TEXAS COMMISSION ON ENVIRONMENTAL QUALITY

PLAIN LANGUAGE SUMMARY FOR TPDES OR TLAP PERMIT APPLICATIONS

Bishop Airfield II, LLC (N/A) proposes to operate Bishop Airfield Ranch Wastewater Treatment Facility (N/A), a Wastewater Treatment. The facility will be located at approximately 0.5 miles southwest from the intersection of Bishop Road and Whitehead Road, in Royse City, Hunt County, Texas 75189. The design of the WWTP will be used to treat municipal wastewater for approximately 2500 single family homes and this permit will not authorize a discharge of pollutants into water in the state.

DATE: AUGUST 2024	DESIGN: CAC	KHA NO.: 063226005	
	DRAWN: JM		
CHECKED: CAC			
SHEET			
AFECTED LANDOWNERS			
BISHOP AIRFIELD RANCH TPDES PERMIT			
Kimley»Horn			
Texas Board Of Professional Engineers Firm Registration Number: F-2028 2808 East Loop West, Suite 100, Houston, TX 77059 Phone: 281-250-2500			
NO.	REVISION	BY	DATE

USGS MAP (2 OF 2)

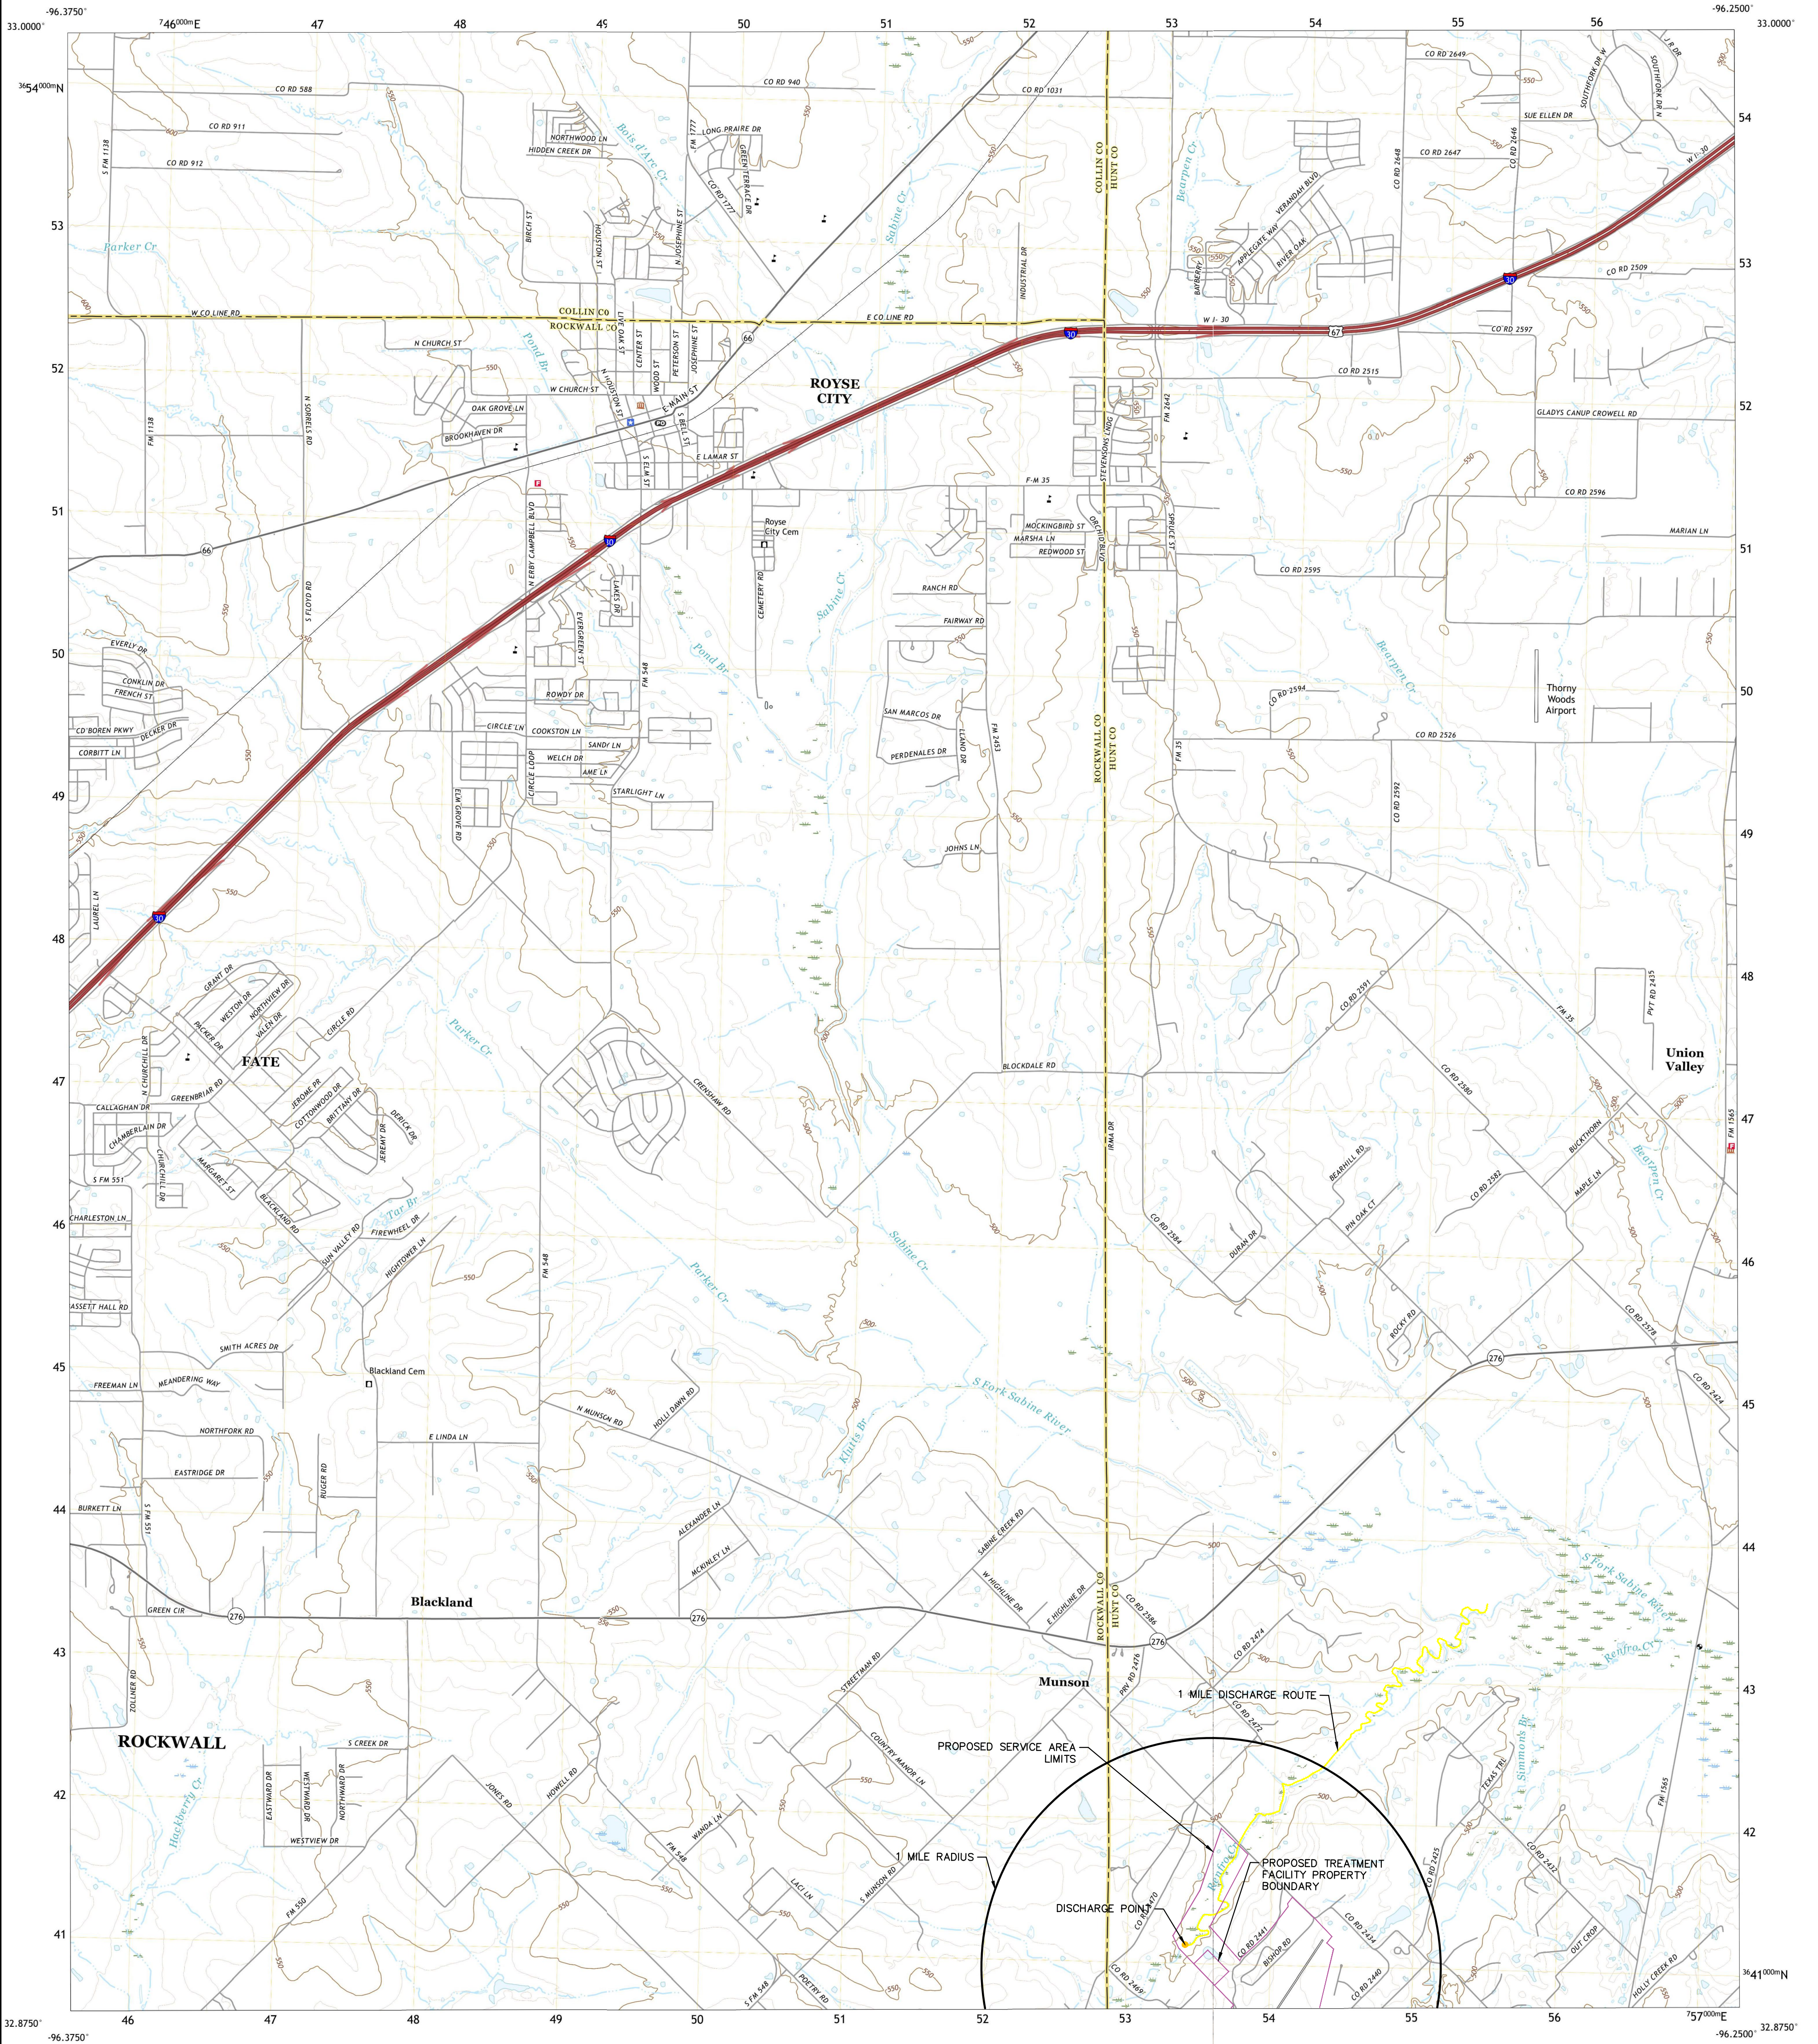
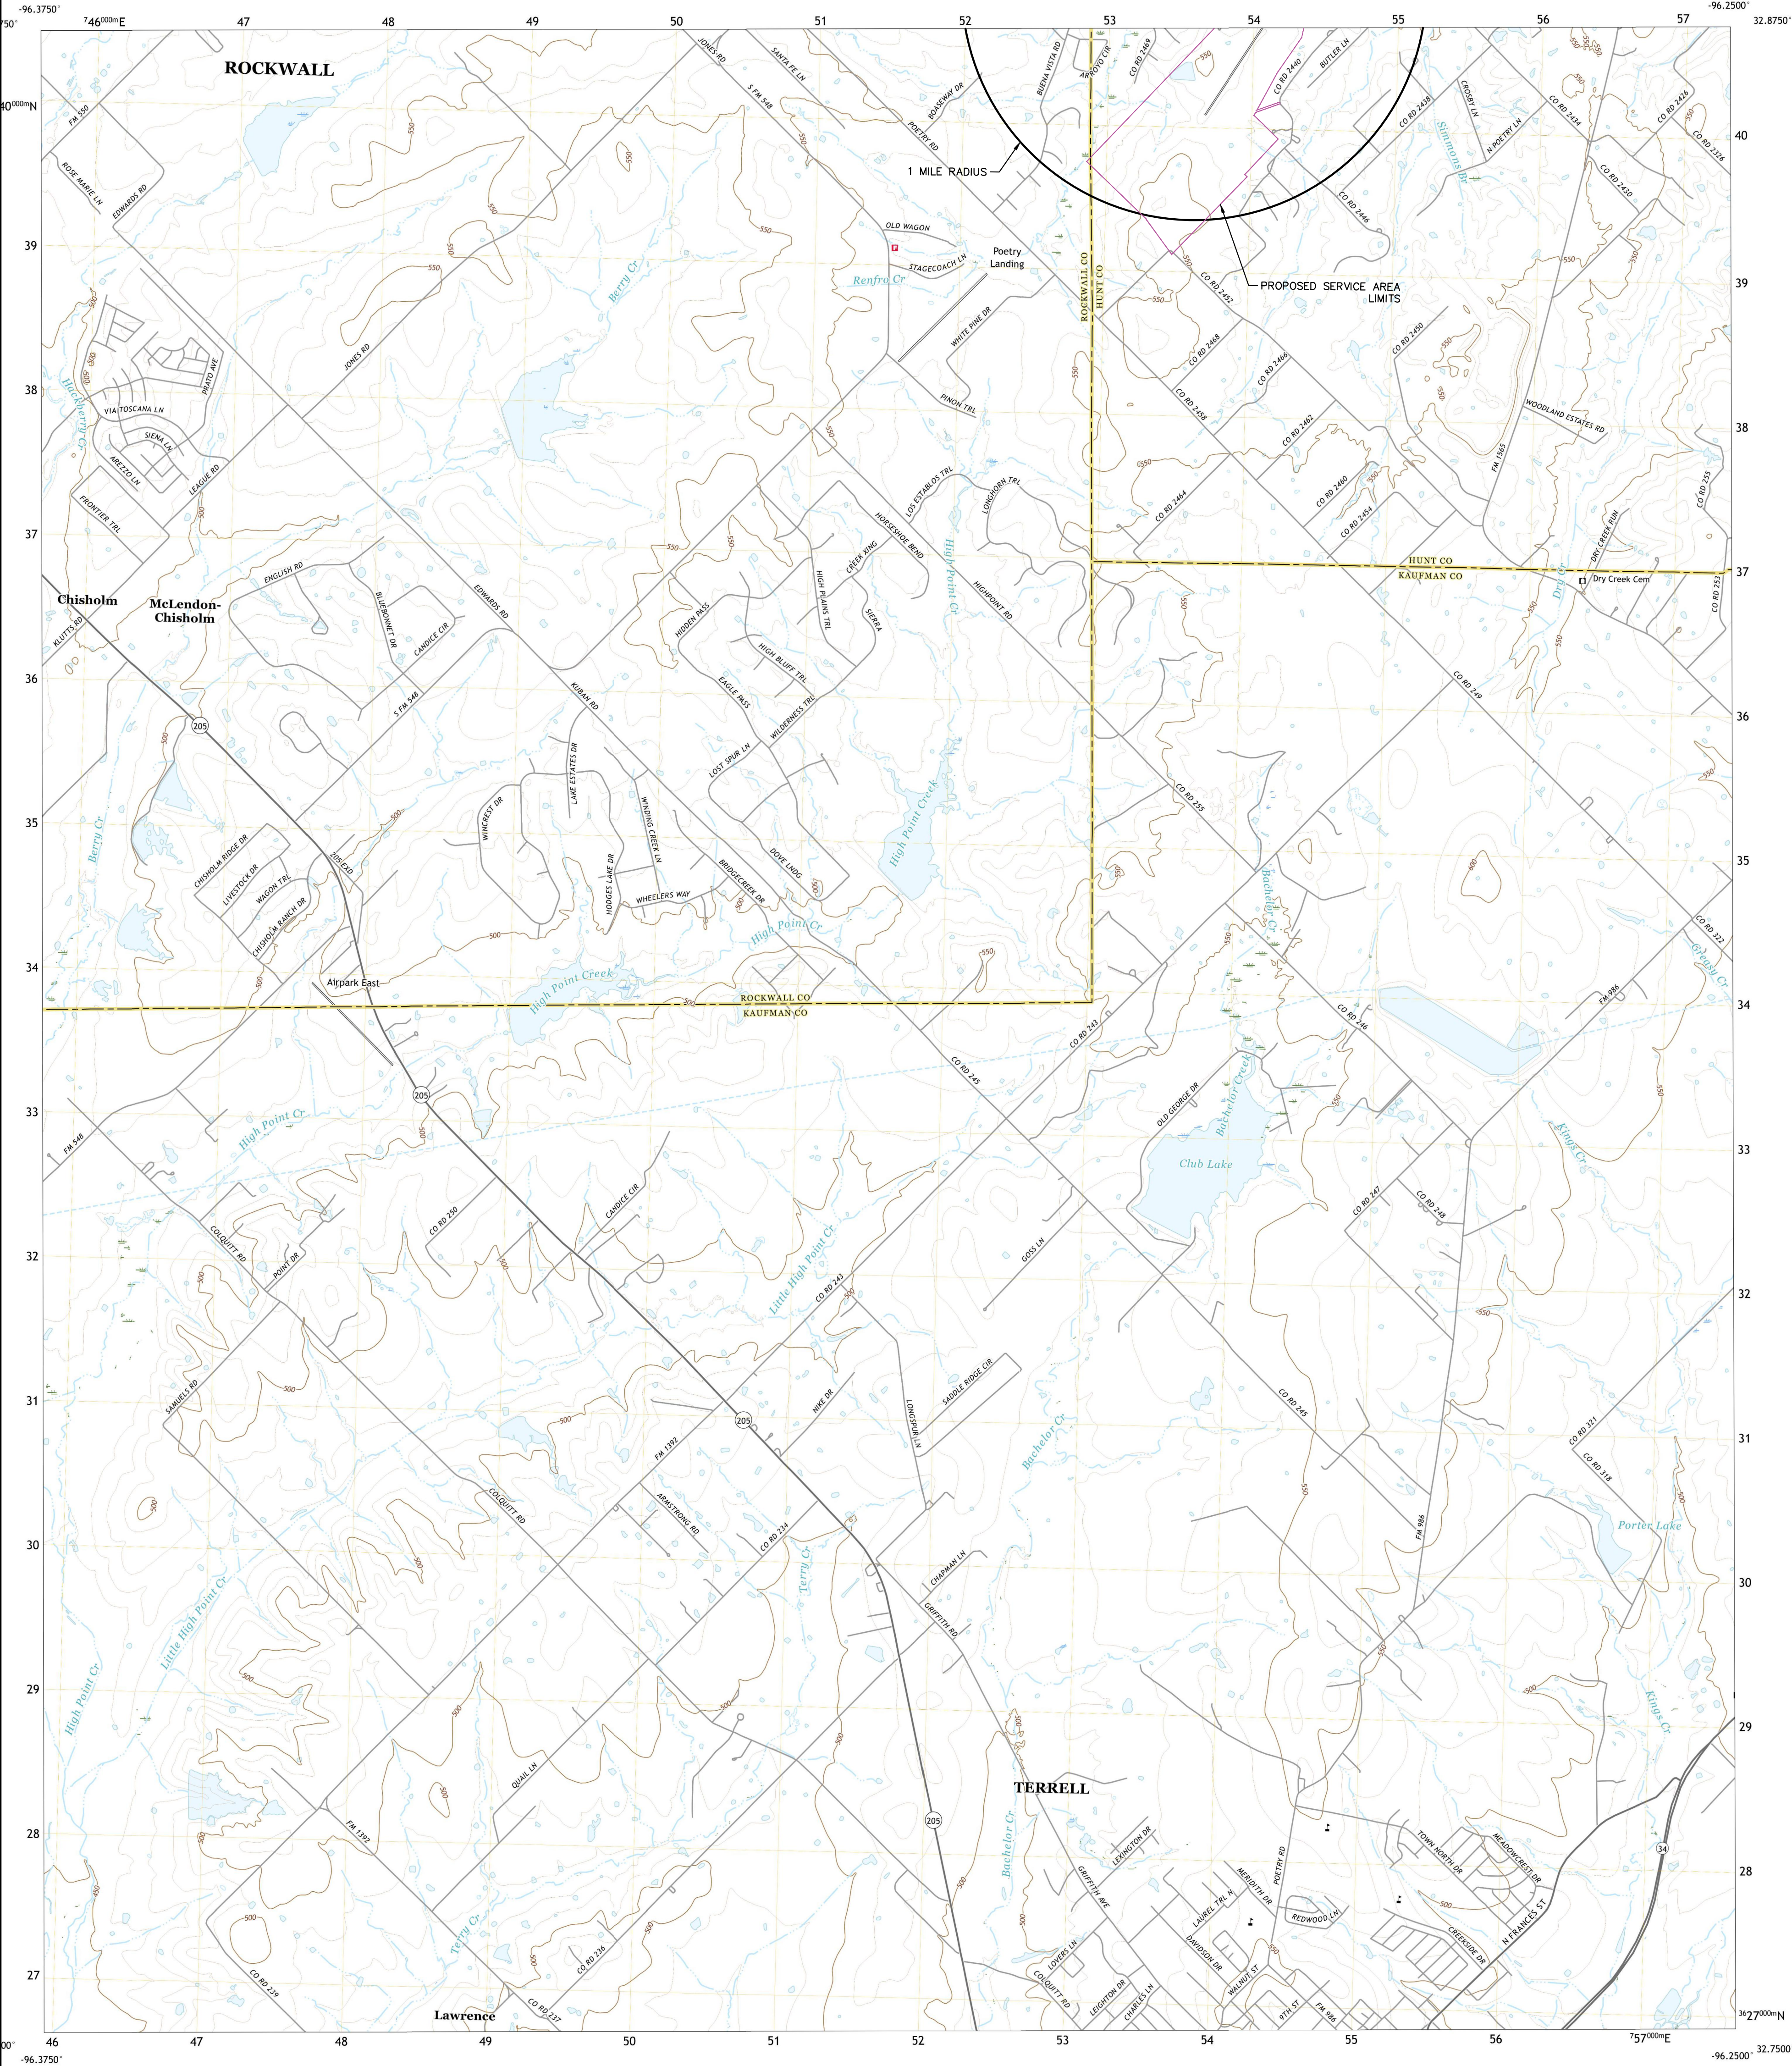
No affected landowner map was found in the application. Please provide an affected landowner map that shows and labels all required items including: applicant's property boundary (including all contiguous land owned by the applicant); treatment facility boundary; property boundaries of all landowners adjacent to the applicant's property boundary; point of discharge and highlighted discharge route for one mile downstream; and all property boundaries of landowners along the discharge route for one mile downstream of the point of discharge.

Response: See the attached USGS map showing labels and all required items.

Response: The affected landowners map has been updated and attached.
